SFD26821
PLAT-15398
PUD
NOT IN WUI

WARNING! 1. LOCATE UNDERGROUND UTILITIES PRIOR TO EXCAVATION. 2. THIS PLOT PLAN SHOWS IMPROVEMENTS AT GRADE ONLY. SEE FOUNDATION PLANS FOR STRUCTURAL INFORMATION.	SITE DATA LOT SQ. FT.= 3540✓ HOUSE SQ. FT.= 1529✓ COVERAGE = 43.2%✓ BLDG. HEIGHT = 26.9✓	PLOT PLAN		
		LEGAL DESCRIPTION LOT 17 ✓ STERLING RANCH FILING No. 5 ✓ EL PASO COUNTY, COLORADO		
AMERICAN LEGEND HOMES 1635 GARDEN OF THE GODS ROAD STE 2130 COLORADO SPRINGS, COLORADO 80907 719-884-0088		ADDRESS 8044 MANOR HOUSE WAY ✓		
		SCALE: ...1"=20' DRAWN BY: TAP	TITLE CO. FILE NO.	DATE 06-24-26
			DRAWING NAME SR5-17	PROJECT NO.

Address: 8044 MANOR HOUSE WAY, COLORADO SPRINGS

Plan Track #: 217422  **Received: 05-Oct-2026 (AMY)**

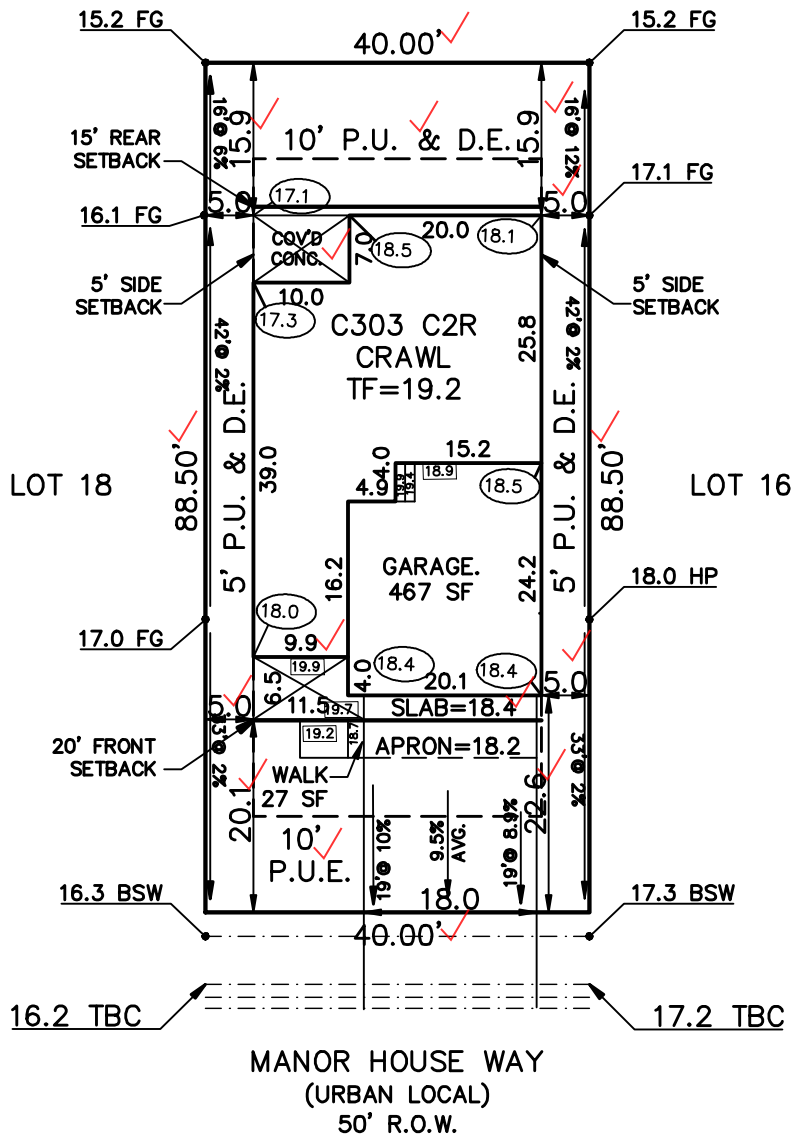
AVERAGE FINISH GRADE = (AFG)
AFG = $\frac{18.5(2)+18.4(2)+18.1+18.0+17.3+17.1}{(8)} = 18.0$
BUILDING HEIGHT = 25.9 + (TS - AFG) =
BUILDING HEIGHT = 25.9 + (19.0 - 18.0) = 26.9

EAVE PROTECTION REQUIRED
